## Appendix C: Fire strategy drawings.

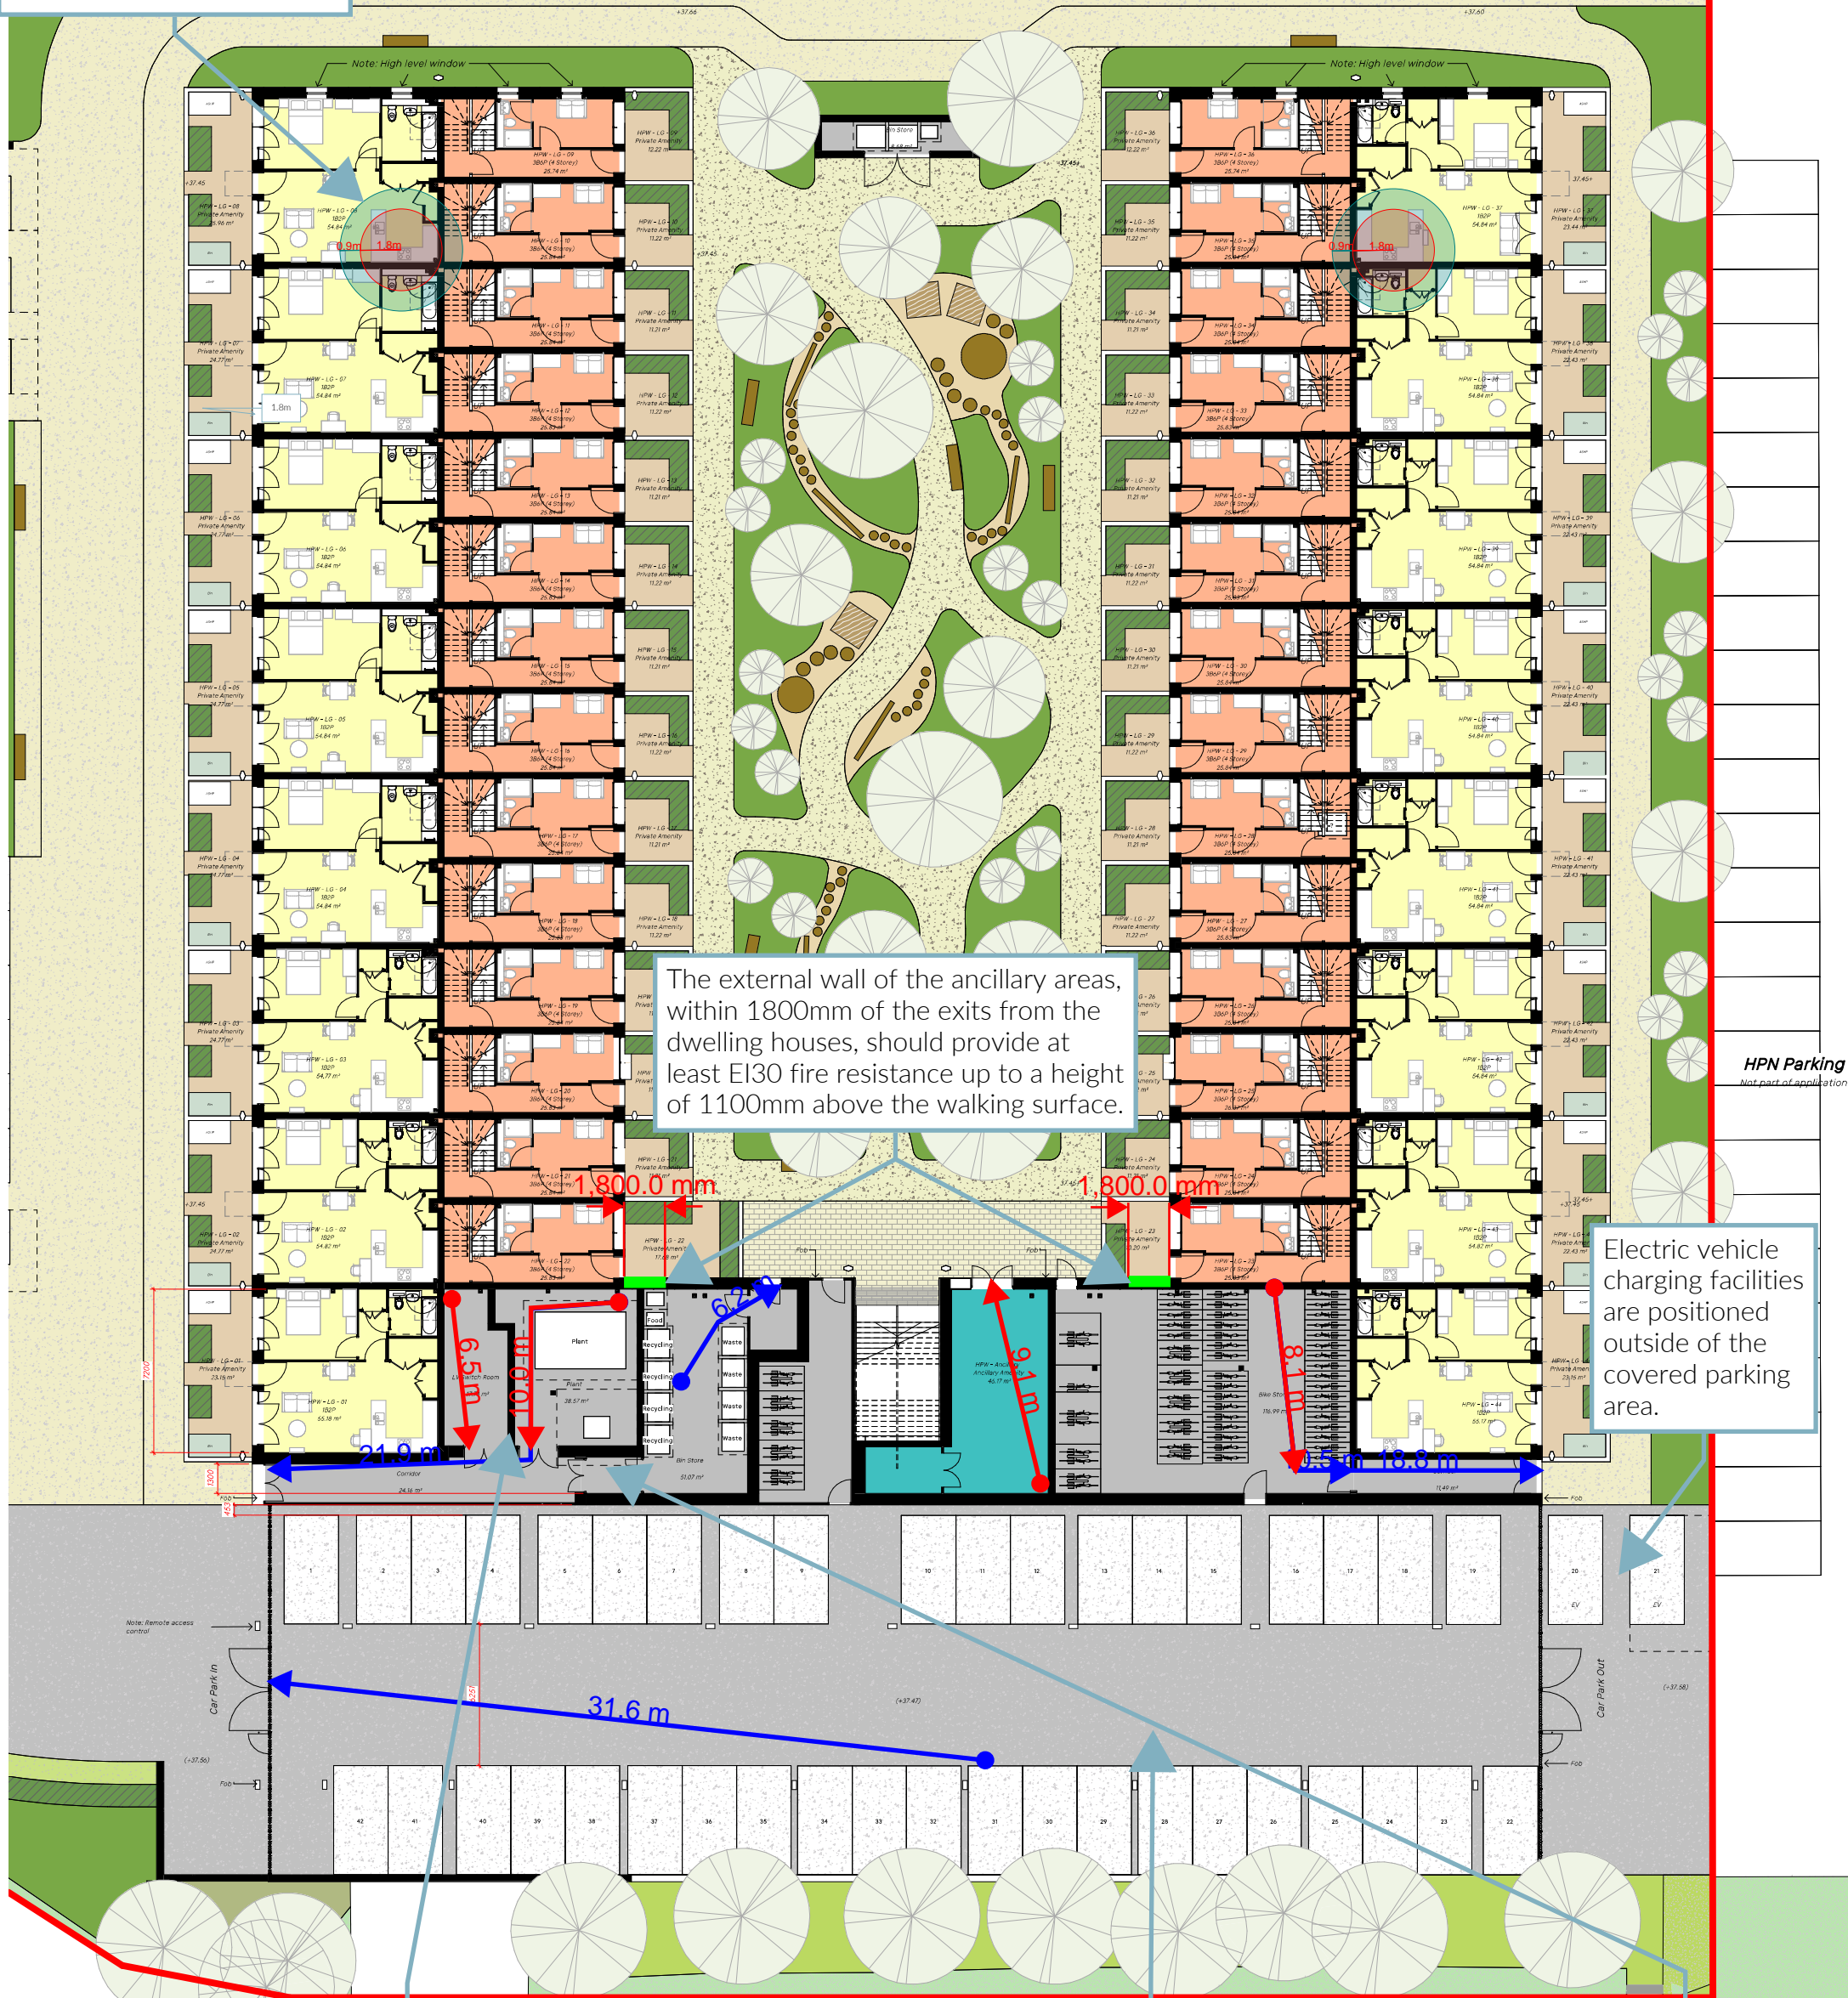
Travel distance exceeds 6m in the LV switch room (within the room and with unknown layouts) and 9m in the lower ground level plant room (within the room and with known layouts).

As layouts are developed and confirmed in the following stage of design, travel distance should not exceed 9m within these rooms. Progressing the design on this basis should be reasonable – subject to discussion and agreement with the approving authorities.

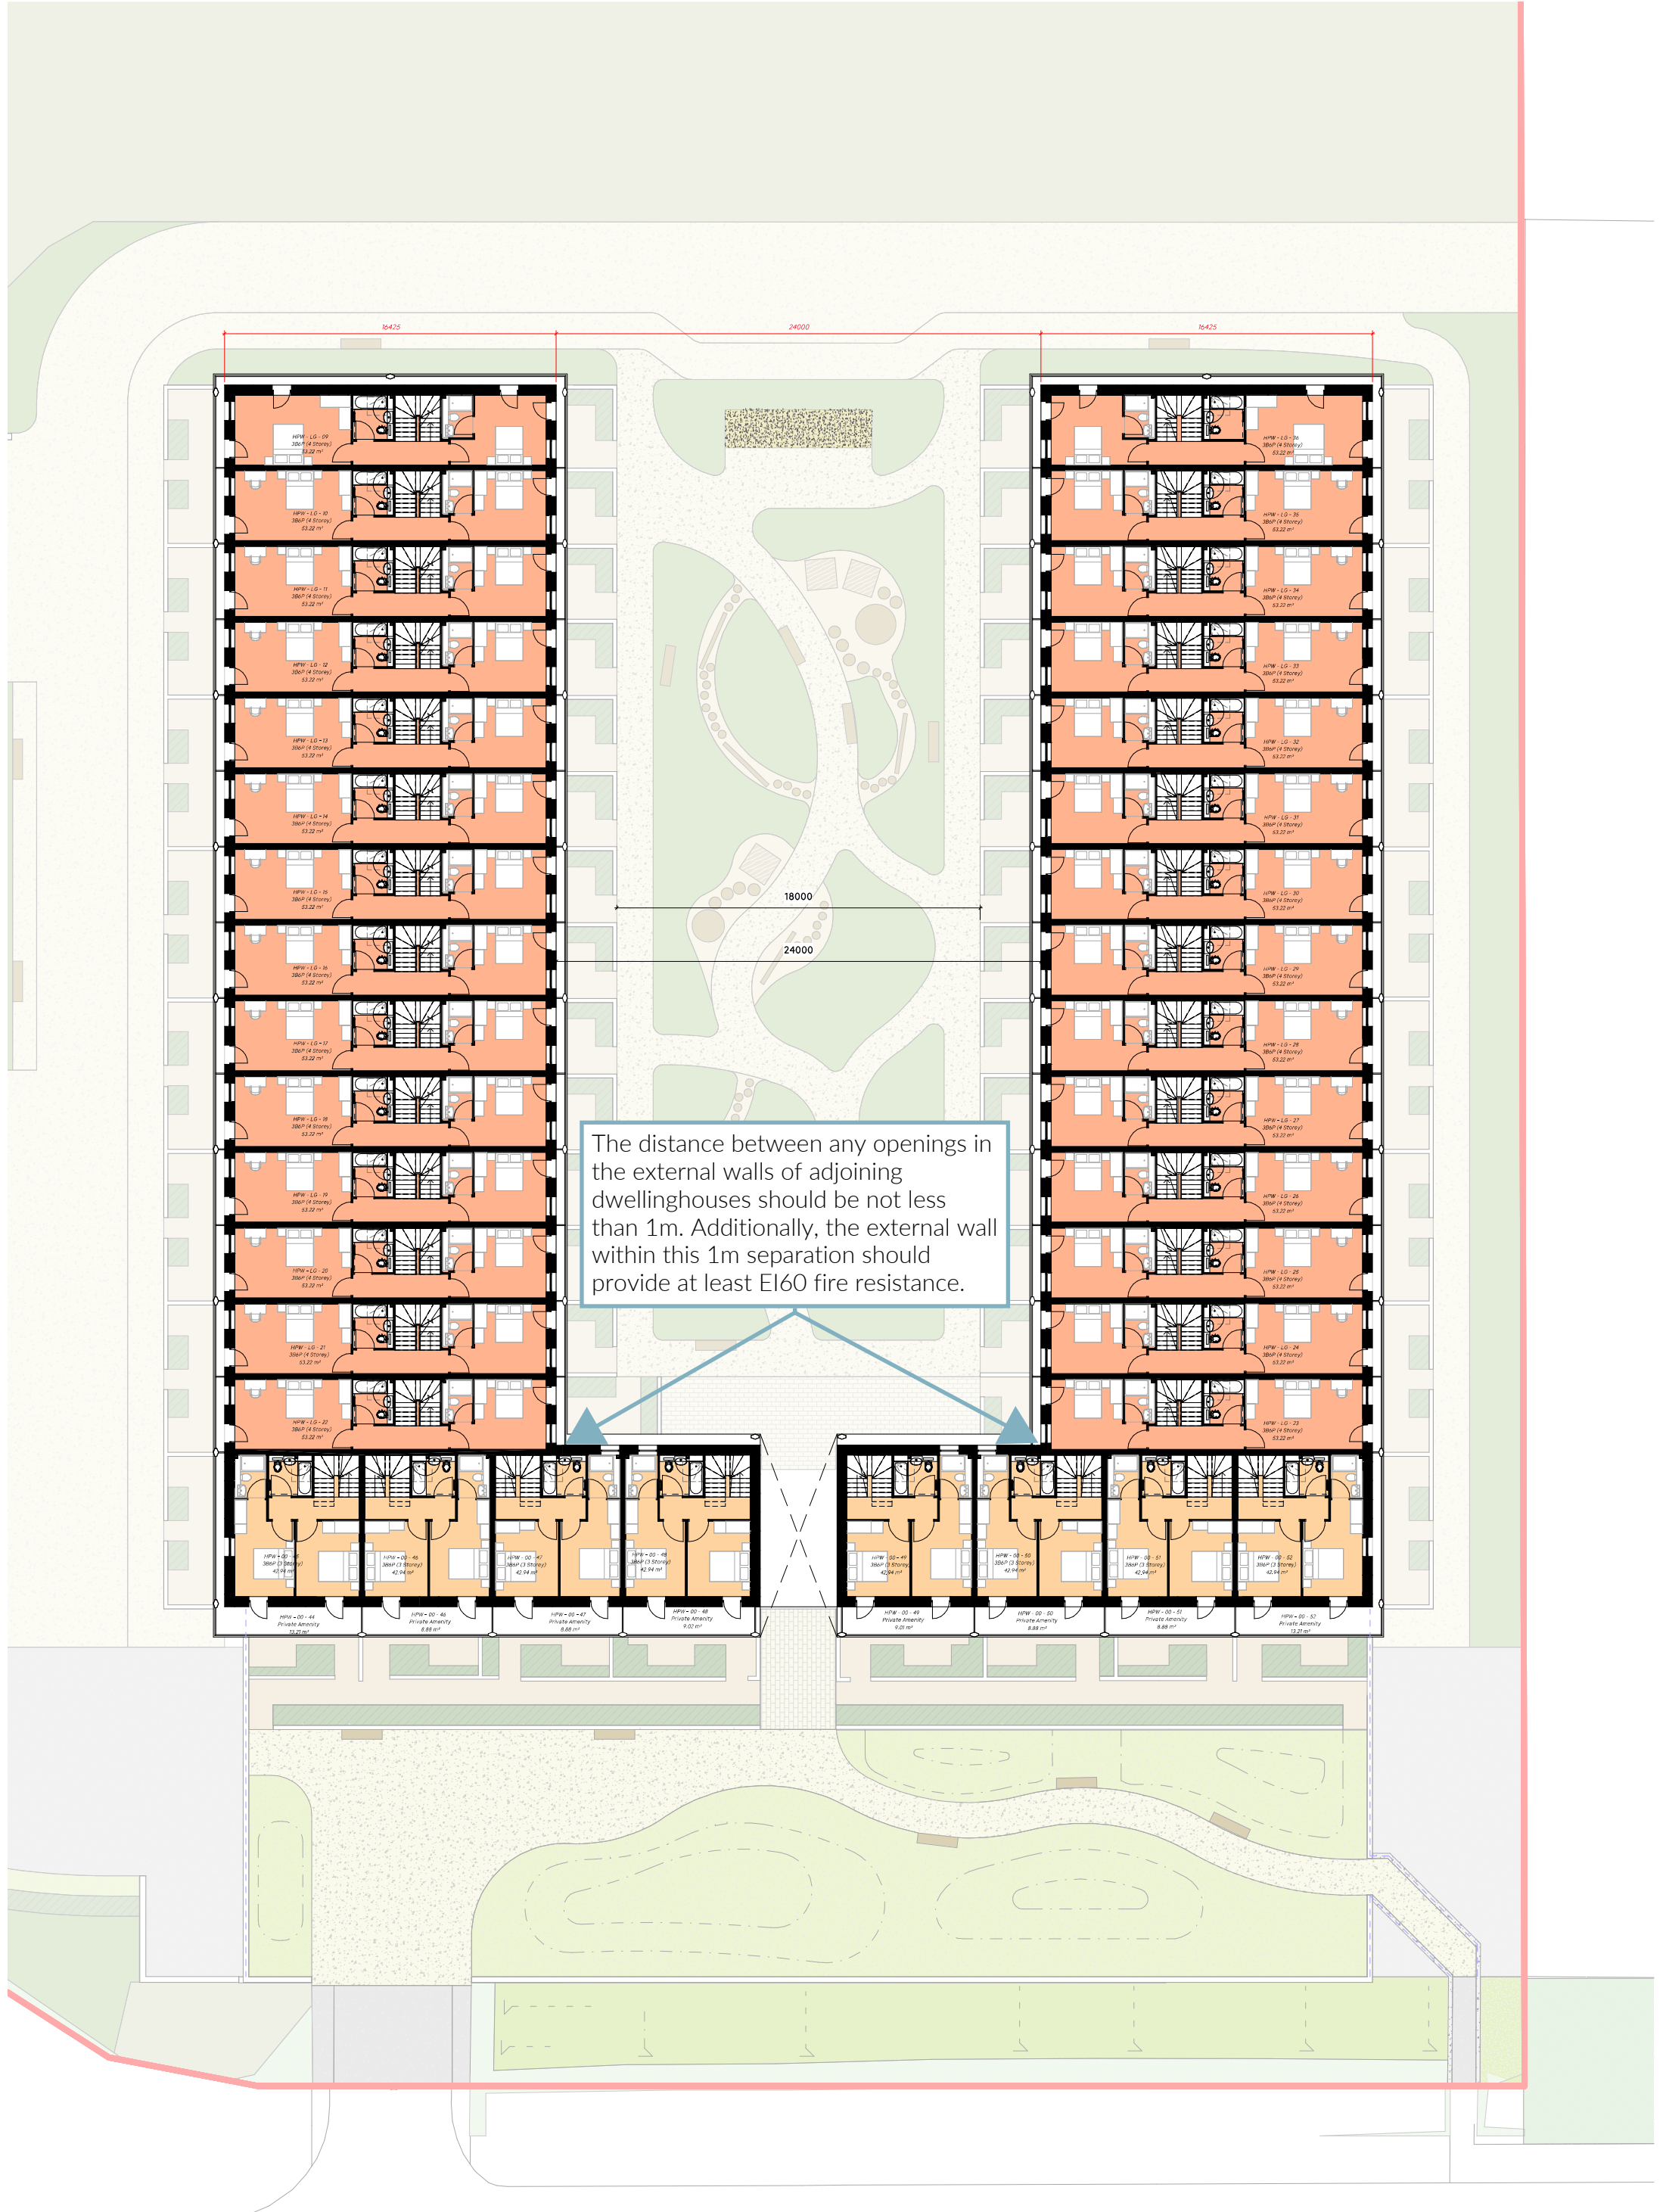
The covered car park shall be naturally ventilated through permanent openings. The ventilation should have an aggregate equivalent area of at least 5% of the floor area of the car park, with at least half of this area equally arranged between two opposing walls. This requirement is understood to be achieved for the covered car park.

Refuse store lobby shall be provided with at least  $0.2\text{m}^2$  (geometric free area) permanent natural ventilation (or equivalent mechanical).

The distance between any openings in the external walls of adjoining dwellinghouses should be not less than 1m. Additionally, the external wall within this 1m separation should provide at least EI60 fire resistance.
